Subject: Oyster Creek Nuclear Generating Station (OCNGS)
Docket No. 50-219
SEP Topic No. VI-7.C.1, Appendix K - Electrical
Instrumentation and Control Re-Review

SEP Topic No. VI-7.C.1, Appendix K-Electrical
Instrumentation and Control Re-Review

Oyster Creek Nuclear Generating Station
Docket No. 50-219

No TCC-1A32

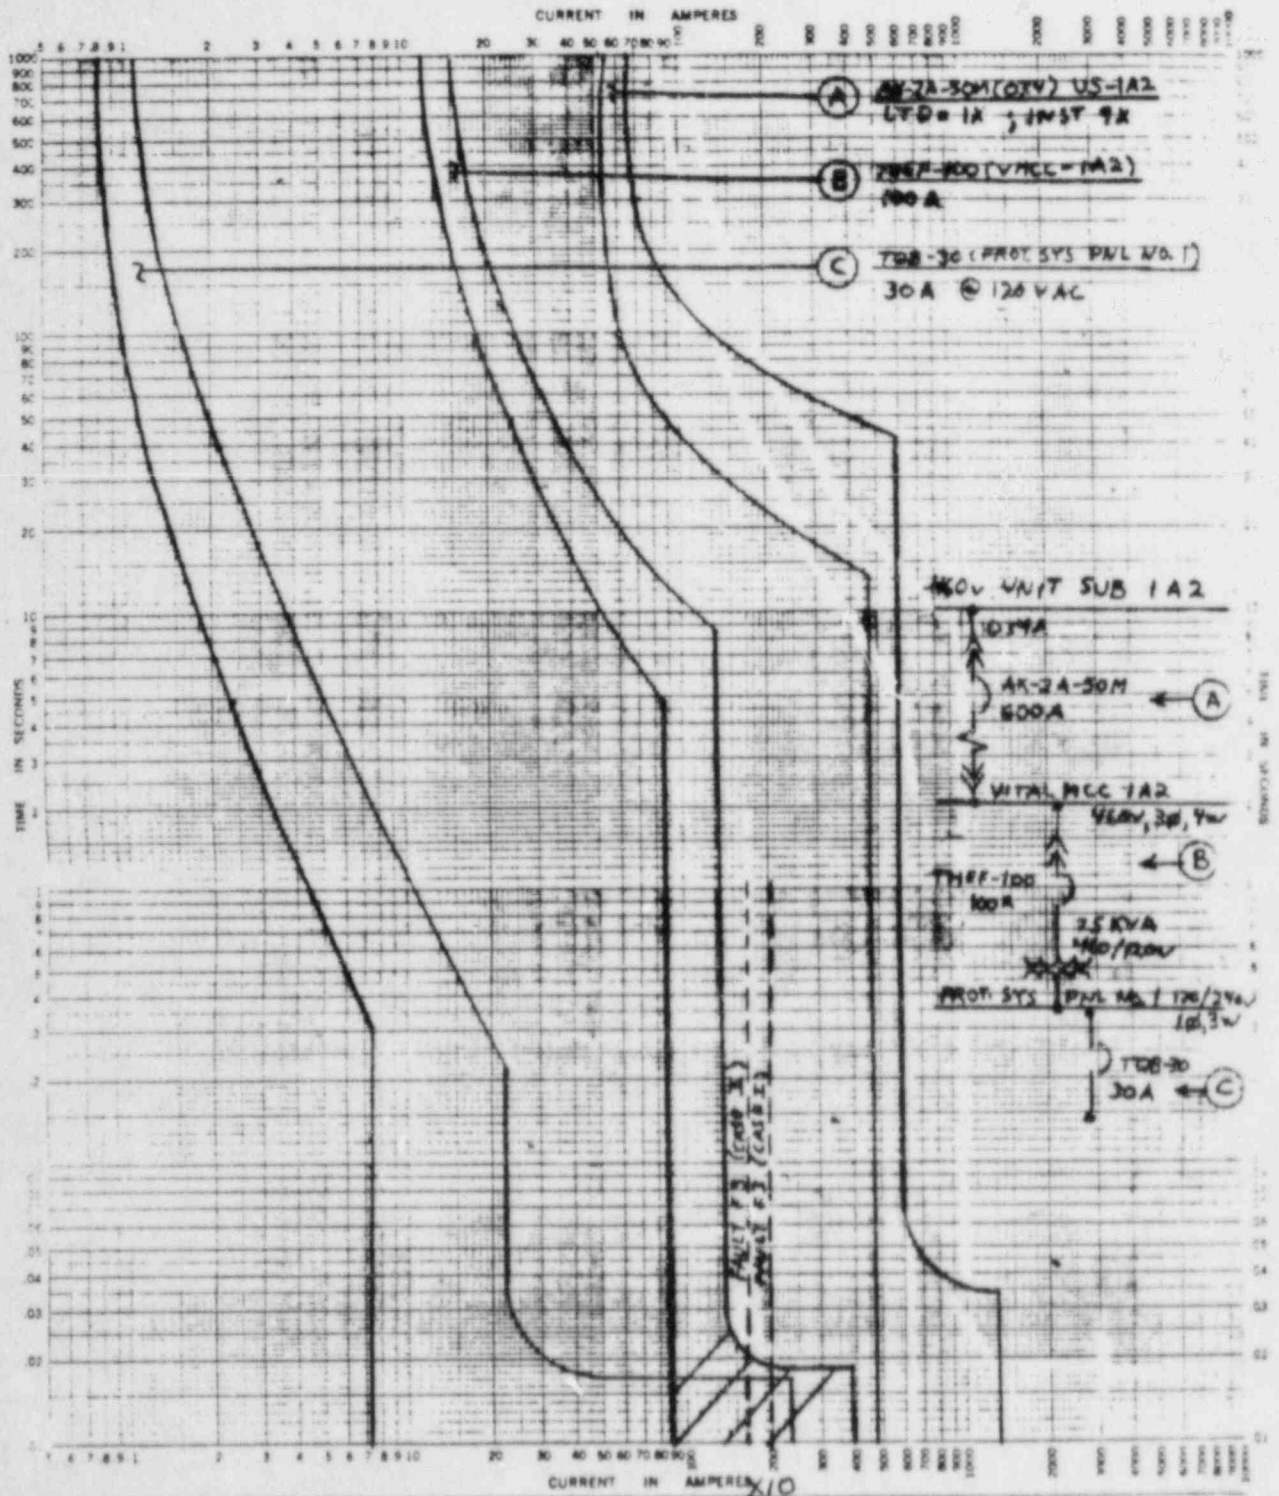
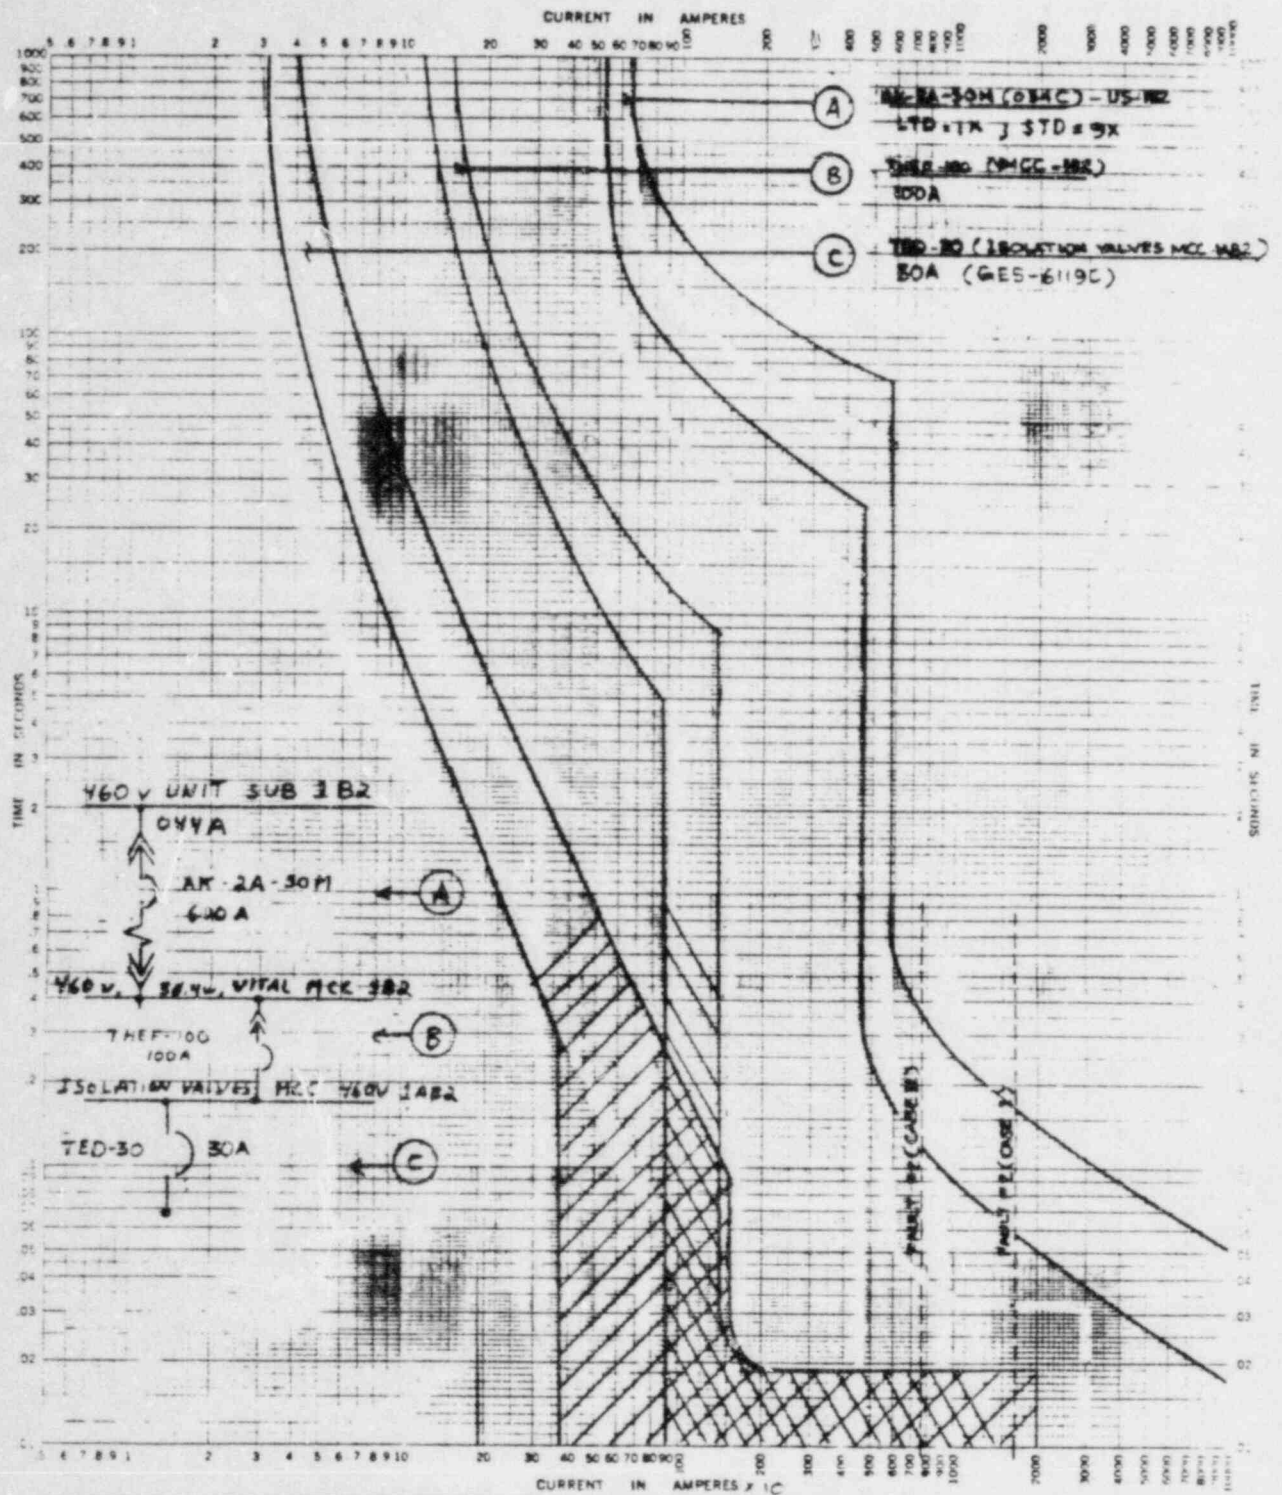
- 4.2.2 Ref. attachment #2 and #7, the fault "F2" will be cleared by the immediate circuit breaker TEF-20 (MCC-1A2) and/or by circuit breaker THEF-100 (VMCC-1A2/B2) and/or by circuit breaker AK-2A-50M-(US-1A2/1B2). Similarly fault "F7" will be cleared by the immediate upstream circuit breaker TEF-70 (Pnl.VLDP-1) and/or by circuit breaker TFK-225(VMCC-1A2/B2) and/or by circuit breaker AK-2A-50M (US-1A2/B2). This could result in the loss of power to both the redundant vital AC buses VMCC-1A2 and 1B2.

- Ref. attachment Nos. 2A and 7A show the same coordination plots as in attachment Nos. 2 and 7, but with type EC-1, 1A-2C, trip unit on breaker AK-2A-50M. This trip unit has a LTD-STD characteristics. A review of these plots shows that with the new recommended trip unit and its shown settings, the faults F2 and F7 will be cleared either by their immediate circuit breaker (TED-30/TEF-70) and/or by their back-up circuit breaker (THEF-100/TFK-225). Thus, the integrity of the redundant power to the vital bus VMCC-1A2/1B2 remains unaffected.

K-E TIME-CURRENT CHARACTERISTIC 48 5258
 REV 1 CHANGED 'BKR' AK-2A-50M PLOT FROM
 LTD-INST. TO LTD-STD.

CHANGED AK-2A-30M BKR CURVE TO LTD-STD FROM LTD-INST. and ISO. VALVE BKR TO TED-30
